1. AGENCY USE ONLY (Leave blank)		2. REPORT DATE 07/00/89	3. REPORT TYPE AND DATES COVERED	
4. TITLE AND SUBTITLE FINAL DECISION DOCUMENT FOR THE GROUNDWATER INTERCEPT AND TREATMENT SYSTEM NORTH OF ROCKY MOUNTAIN ARSENAL, INTERIM RESPONSE ACTION			5. FUNDING NUMBERS

FINAL DECISION DOCUMENT
FOR THE
GROUND-WATER INTERCEPT AND TREATMENT
SYSTEM NORTH OF ROCKY MOUNTAIN ARSENAL
INTERIM RESPONSE ACTION

July 1989

Figure 1-2
IRA STUDY AREA

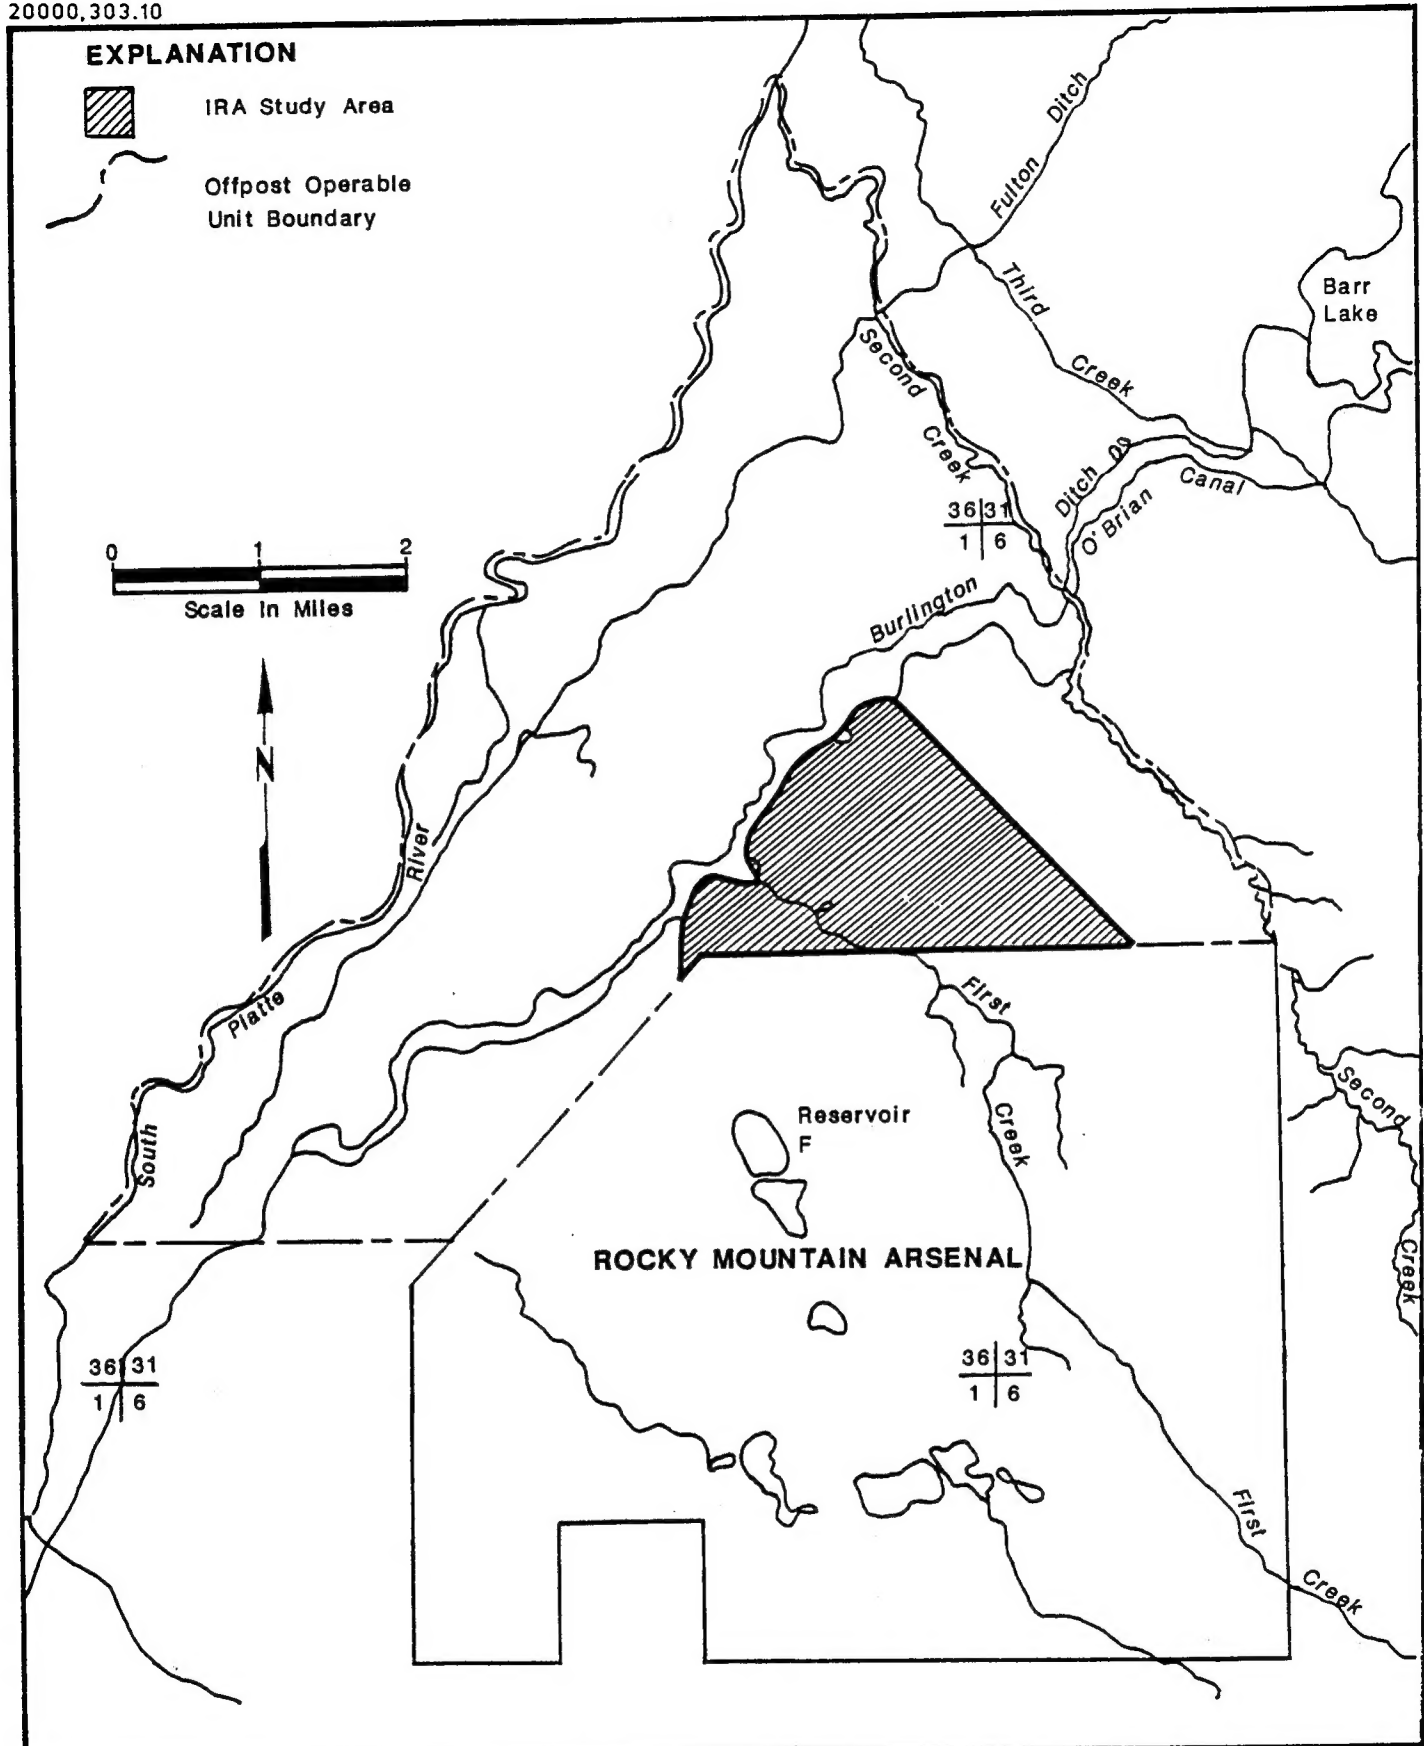
2. Pp. 2-3 and Figure 1-2. The study area is too restrictive to meet all of the objectives of this interim action. The State concurs that the groundwater intercept and treatment systems should be sited within the bounds of the proposed study area. However, RMA contaminants are known to exist in the groundwater as far north as the South Platte River. Therefore, the study area must be expanded to include all off-post areas which may require alternate water supplies and/or monitoring.

Pp. 2-3 and Figure 1-2. The study area is too restrictive to meet all of the objectives of this interim action. The State concurs that the groundwater intercept and treatment systems should be sited within the bounds of the proposed study area. However, RMA contaminants are known to exist in the ground water as far north as the South Platte River. Therefore, the study area must be expanded to include all off-post areas which may require alternate water supplies and/or monitoring.

The study area shown defines the area within which the ground-water intercept and recharge system will likely be located. The need for alternative water supplies over a broader area is being reviewed in the Offpost EA/FS. The document has been revised to indicate the current alternative water supply program, outside the scope of this IRA, will be continued and an alternative water supply will be provided immediately if a well is found to contain RMA-derived contaminants above established health criteria.

Figure 2-2
UNSATURATED ALLUVIUM AND PRIMARY
FLOW PATHS IN VICINITY OF IRA
STUDY AREA

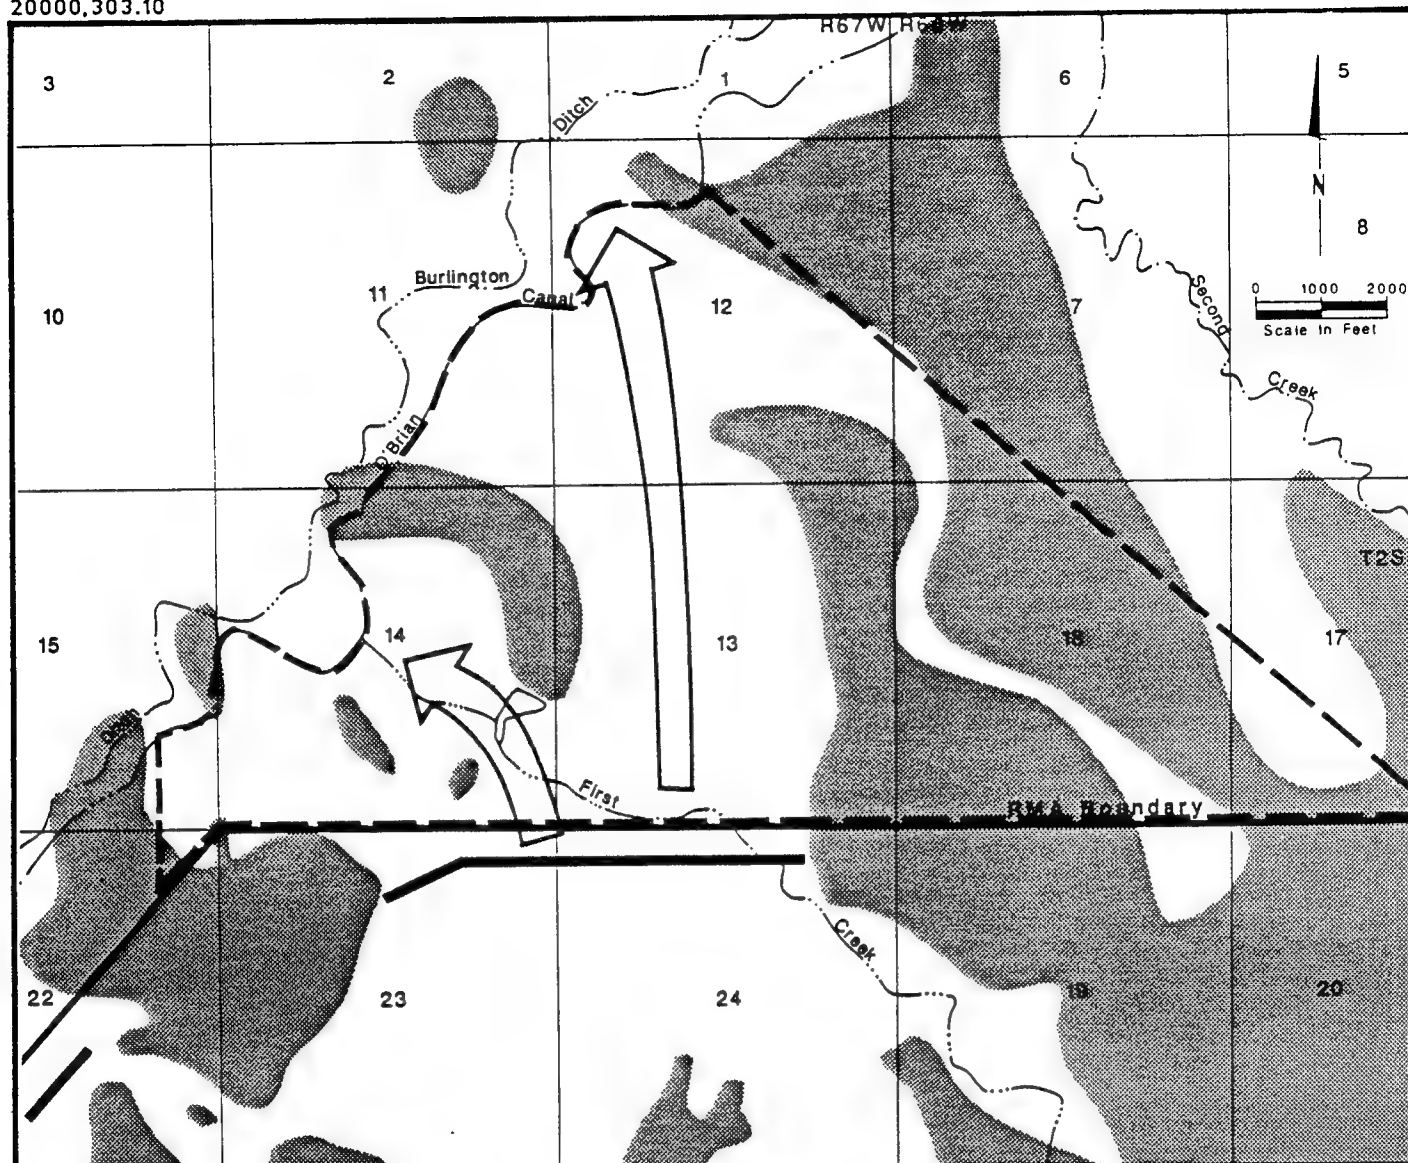
The primary groundwater flow path towards the North Boundary Containment System does not go through Section 23 as implied by the location of the arrow on the Figure. A much larger groundwater flow migrates towards the boundary system through Section 24, near First Creek.

The primary groundwater flow path towards the North Boundary Containment System does not go through Section 23 as implied by the location of the arrow on the figure. A much larger groundwater flow migrates towards the boundary system through Section 24, near First Creek.

The primary groundwater flow path towards the North Boundary Containment System does not go through Section 23 as implied by the location of the arrow on the figure. A much larger groundwater flow migrates towards the boundary system through Section 24, near First Creek.

The figure has been modified in response to this comment.
